RAI Responses

CHAPTER 1 GENERAL INFORMATION

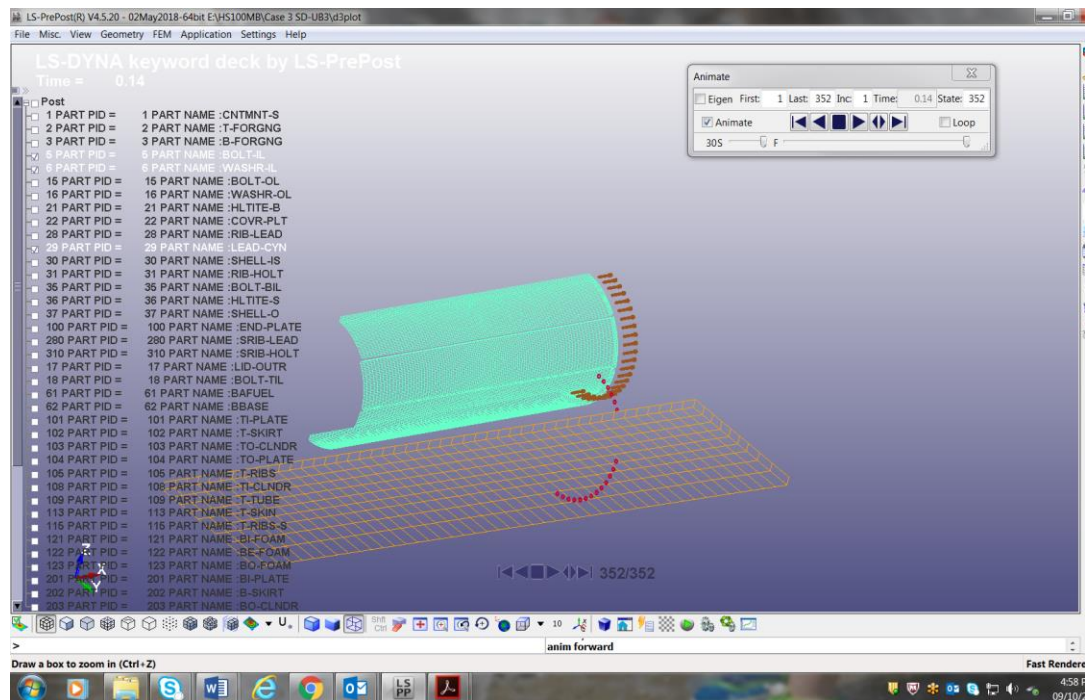
The LS-DYNA results of Case 3 SD-UB3 (portrayed below), show that, at some point during the drop simulation, the inner lid washers (LS-DYNA 6 Part PID = 6 Part Name Washr-IL) seem to move separately from the bolts. It is not clear to the staff if this situation is realistic, and if containment can be maintained. The following needs to be addressed:

- a. Clarify if the observed behavior is in fact expected and, if so, describe how the containment boundary is maintained with the absence of the washers.
- b. If the observed behavior is not expected, revise the model for this and all simulated drop scenarios, as appropriate.

The slapdown analysis (Case 3 SD-UB3) is performed for the governing XL version of the HI-STAR 100MB cask, which is used to transport a loaded MPC so only the outer closure lid is needed. Therefore, the inner lid is removed from the LS-DYNA model of the Version XL package. The inner lid bolts and inner lid bolt washers were unintentionally left in the model, but not included in any of the contact definition. Since they do not interact with the rest of the package in the LS-DYNA model, their presence in the slapdown analysis model has no effect on the analysis results. Thus, the loose inner lid washers identified by the reviewer are of no concern and are not an indication a containment breach. Identical results would be obtained if the simulation were repeated after removing the inner lid washers from the model.
